PLANNING

TO:	Council	
DATE:	February 21, 2023	DIVISION: 6
TIME:	Afternoon Appointment	
FILE:	1015-251	APPLICATION: N/A
SUBJECT:	Adoption of proposed Bylaw C-8020-2020 (Janet Area Structure Plan Long-Term Development Area)

Map 3:
Existing
Land Use

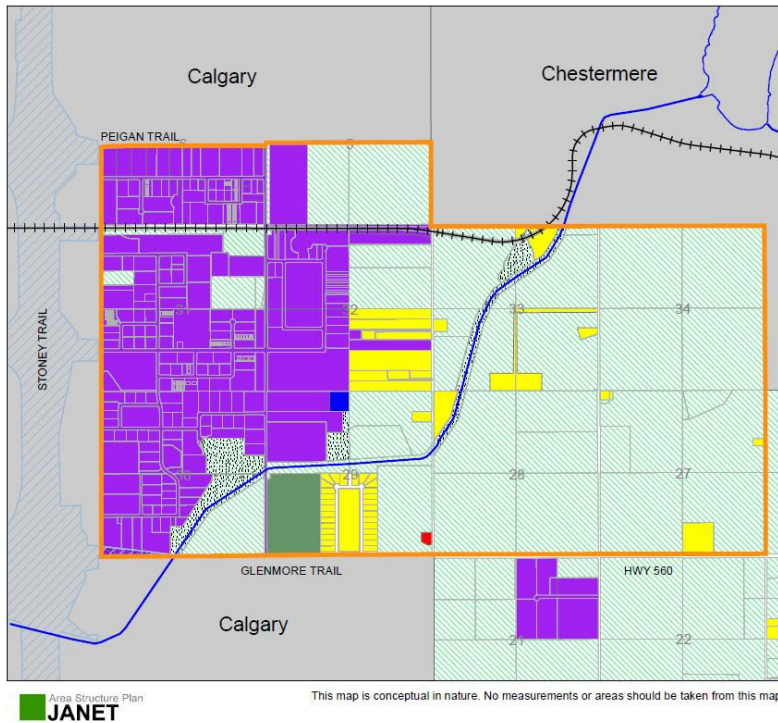
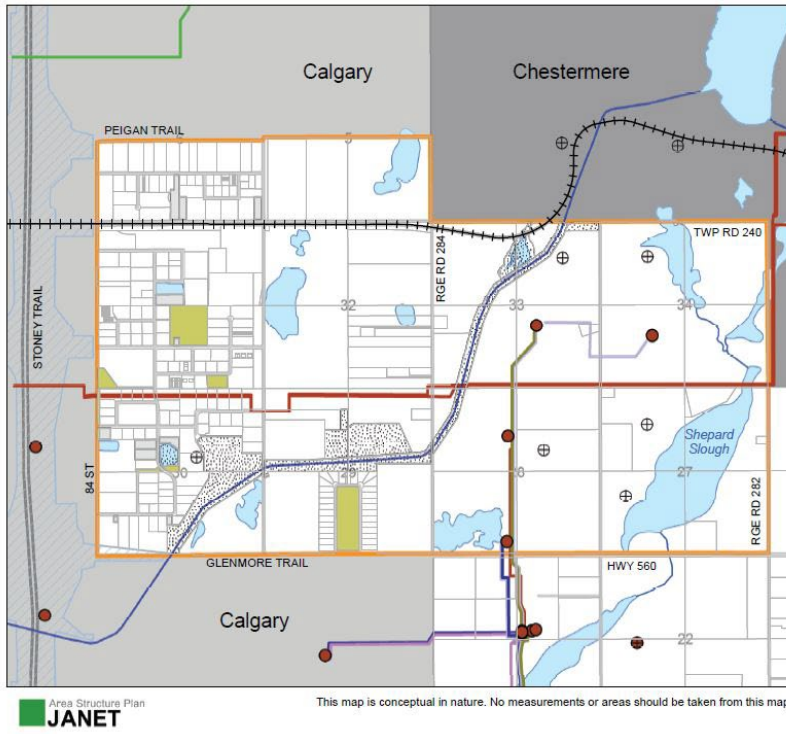
Delete Map 3: Existing Land Use:

And replace with the following:

Map 10:
Phasing

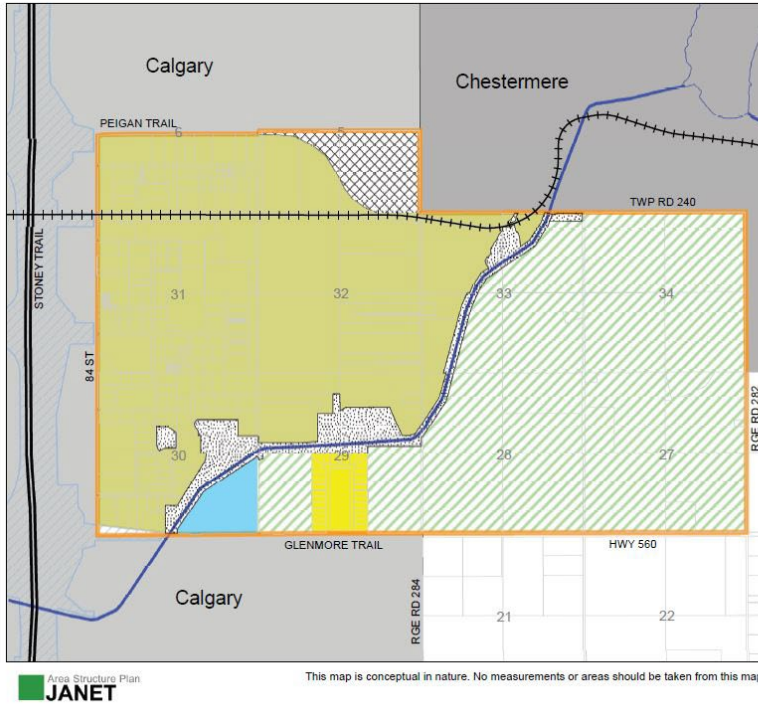
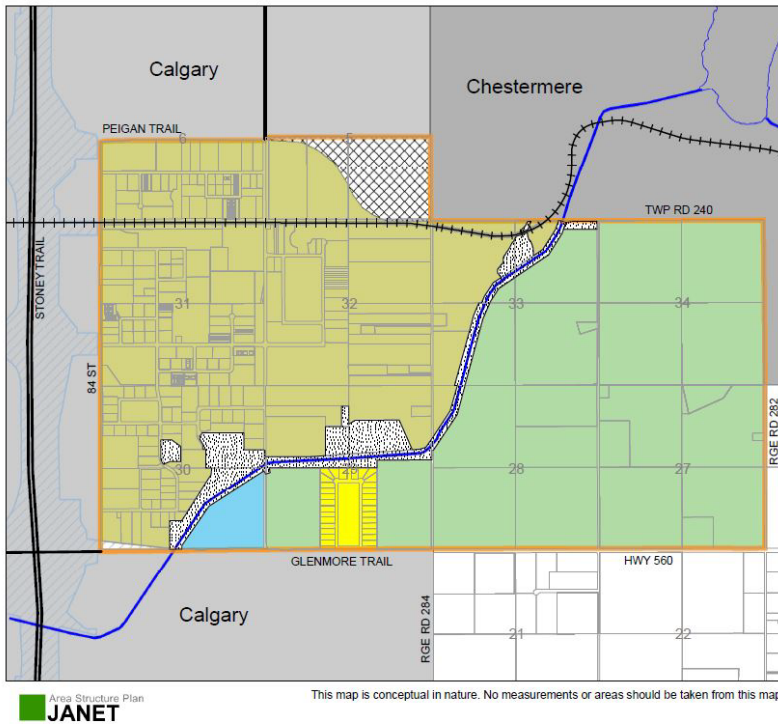
Delete Map 10: Phasing

And replace with the following:
